Project Name	Job #	Inspection Report #1
Champion Centre Geotechnical Soil Observation Report	12895	
Address / Parcel No.	Date	Page
XXX Steilacoom Dupont RD SW / 0119362043	August 24, 2023 <i>Revised 10/14/2024</i>	1 of 12
City / County	Permit #	Arrival Time: 1:00 pm (5/18/2023) 12:30 pm, (8/11/2023)
Client	Project Manager	 <p>10/14/2024</p> <p>State of Washington 1604 Licensed Geologist WILLIAM D. CREVELING</p>
Mustard Seed Legacy Development, LLC (c/o David Rich)	Damon DeRosa, P.E.	
Contractor	Project Geologist	<p>10/14/2024</p> <p>BC</p> <p>State of Washington 1604 Licensed Geologist WILLIAM D. CREVELING</p>
James Moynan Excavating	Bill Creveling, L.G.	
Weather	n/a	<p>10/14/2024</p> <p>BC</p> <p>State of Washington 1604 Licensed Geologist WILLIAM D. CREVELING</p>
Type of Work Performed	Perform soil observations via soil pit excavation to determine characteristics applicable for foundation support, drainage, and constructability of the proposed development. Review 'Critical Slope' characteristics per Chapter 25.105.030.345

*The purpose of this revised report is to add additional information specifically related to the Gray & Osborne review comments dated February 22, 2024. Specif

**Figure 2: Proposed Champion Center with Test Pit Locations**

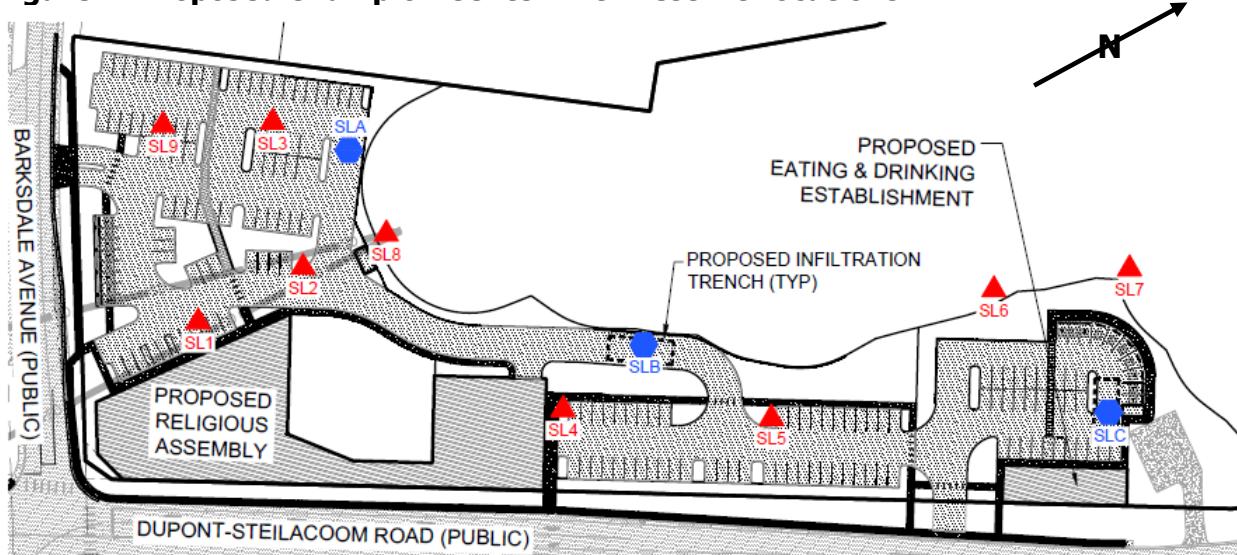
58. Per the DOE Manual, a minimum of two test pits are required per infiltration trench location. Figure 2 of the Geotechnical Soil Report shows 1 test pit at Infiltration Trench #1 and none at Infiltration Trench #2. Additional test pits should be provided or the Geologist provides supplemental documentation that determines the conditions are relatively uniform and the borings/test pits omitted will not influence the design or successful operation of the BMP.

*As soil logs A, B, and C illustrate, the outwash deposit is consistent in terms of depth and coarseness over a large area or entirety of the site. The deposit itself is responsible for the consistent terrain throughout the site.*

*Our sampling points exhibited the consistency of the outwash deposit over large areas. We are confident that the expanse of this flood deposit is well established with the 11 test pits excavated throughout the site. An additional test pit in close proximity to any other test pit would exhibit the same conditions. The number and locations of sampling points are definitive in our opinion for the stormwater design.*
